Subject: Callaway Plant, Unit 1 - Amendment No. 7 to License NPF-30

Amendment No. 7  
License No. NPF-30

SAFETY EVALUATION BY THE OFFICE OF NUCLEAR REACTOR REGULATION  
SUPPORTING AMENDMENT NO. 7 TO FACILITY OPERATING LICENSE NO. NPF-30

FIGURE 6.2-1  
OFFSITE ORGANIZATION

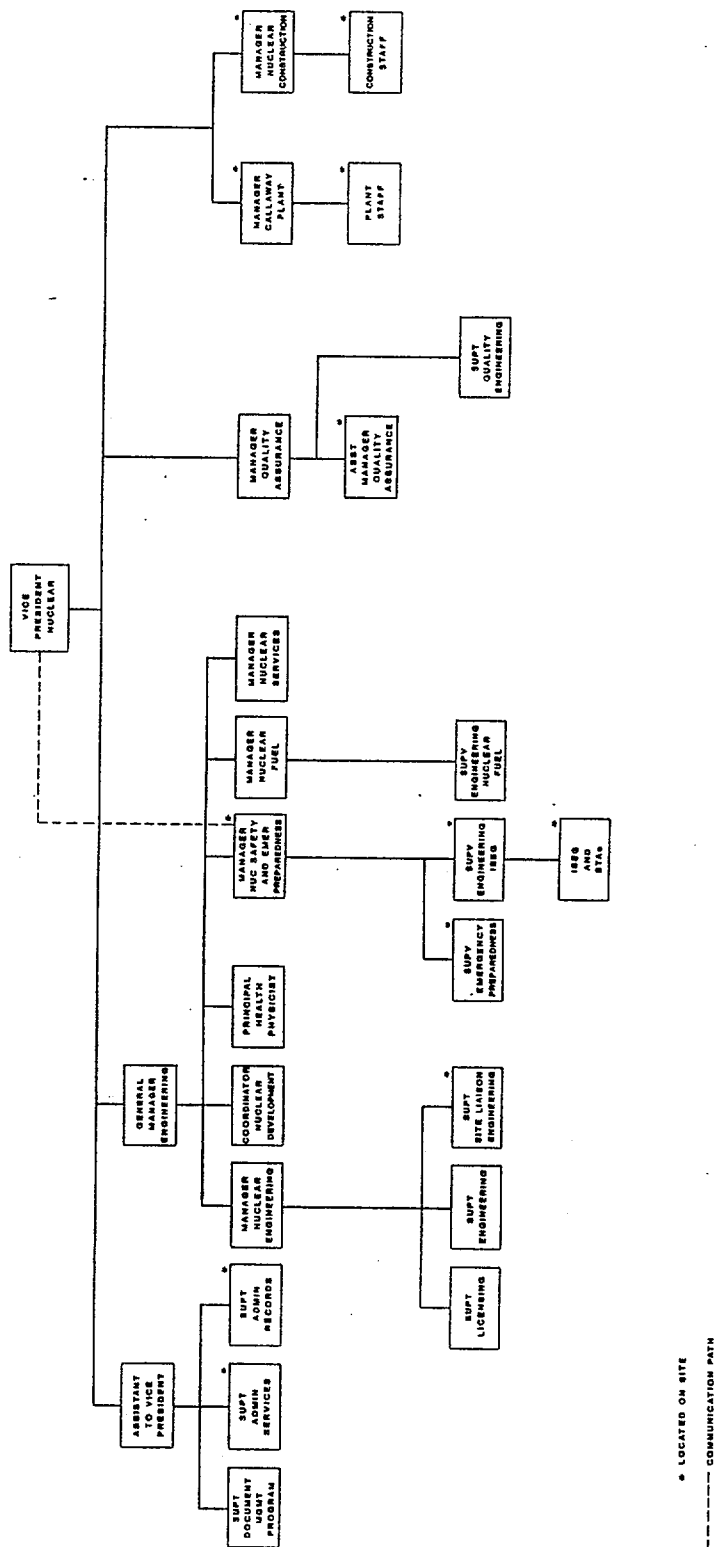
In an effort to reduce the level of detail and produce a more general offsite organization chart, several lower level supervisory and staff positions have been deleted from Figure 6.2-1. The more senior managerial positions responsible for major functions (i.e., operations, technical support, environmental health and safety, quality assurance, and administration) remain on the chart.

The revised chart will give the licensee more flexibility to make certain supervisory-level and staff-level changes without having to process a formal Technical Specification amendment. The revisions do not involve any changes in management responsibilities, reporting relationships, or commitments.

Chapter 13 (Conduct of Operations) of the Callaway Final Safety Analysis Report (FSAR) will continue to describe the offsite organizational structure down to the staff level. The licensee has stated, in the application for this amendment, that the "positions deleted from Technical Specification charts remain described in the Figures and content of Chapter 13 of the Final Safety Analysis Report."

The staff has reviewed the licensee's proposal and finds it acceptable. The revised Figure 6.2-1 adequately describes the lines of authority and communication among the major corporate organizational units involved in the management, technical support, and operation of Callaway Unit 1.

FIGURE 6.2-2  
UNIT ORGANIZATION

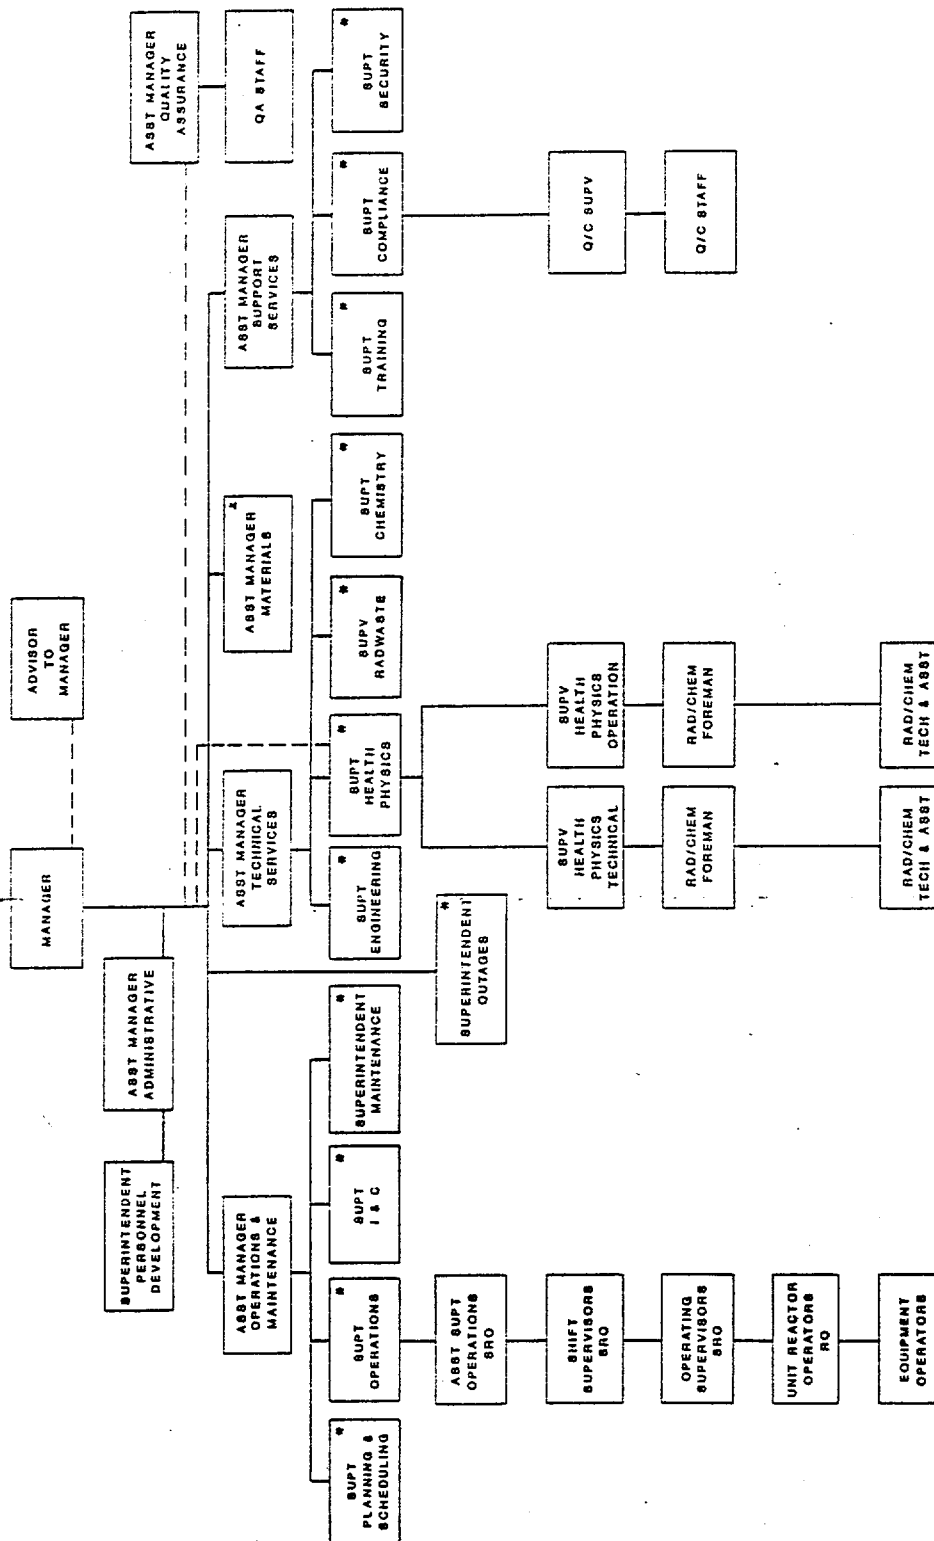
1. Callaway Unit 1 has a staff of Shift Supervisors, all of whom are licensed at the senior reactor operator (SRO) level. Each operating shift crew is assigned a Shift Supervisor, who has on-shift management responsibility for safe plant operation.

The Technical Specification figure specifying a nuclear plant's site organization normally encompasses the operational chain of command down to the nonlicensed operator level, which of course includes the Shift Supervisor. In the case of Callaway, the Shift Supervisor position does not appear on the current onsite organization chart; however, the licensee now proposes to add the position to Figure 6.2-2.

2. The box for the Quality Assurance Staff on the current Unit Organization Chart contains a cross-reference to Figure 6.2-1 for further detail; however, the proposed change to Figure 6.2-1 described above in Section A of this evaluation would delete the information on QA staff positions below the Assistant Manager, Quality Assurance. Therefore, the cross-reference to Figure 6.2-1 has been deleted from Figure 6.2-2.

The staff finds the licensee's proposal acceptable because it more accurately represents the operational chain of command.

The staff finds the licensee's proposal acceptable because it is an editorial change designed to conform Figure 6.2-2 to the revised Figure 6.2-1.
